NUMBER: 18-078-16 REV. A

Engine Oil Viscosity Upgrade And Flash Enhancements

2016 (WK) Jeep Grand Cherokee 2016 (DS) Ram 1500 Pickup

Fig. 1 Cap Before Sticker Applied

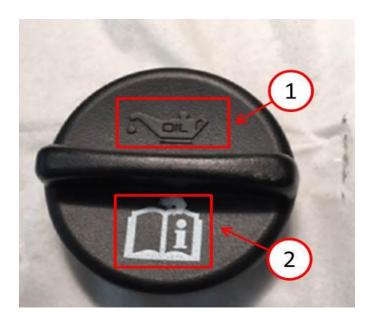
- 5. Run engine for 10 minutes before oil change to warm up the engine oil.
- 6. Remove oil fill cap.
- 7. Clean top of oil fill cap with Isopropyl alcohol or equivalent and apply engine oil viscosity rating sticker as shown in (Fig. 1).

- 1 Do Not Cover This Embossed International Oil Symbol
- 2 Cover This Old Oil Info Symbol With The New "5W40" Label
- 8. Remove the oil drain plug and allow oil to drain for at least 5 minutes or until it stops dripping.
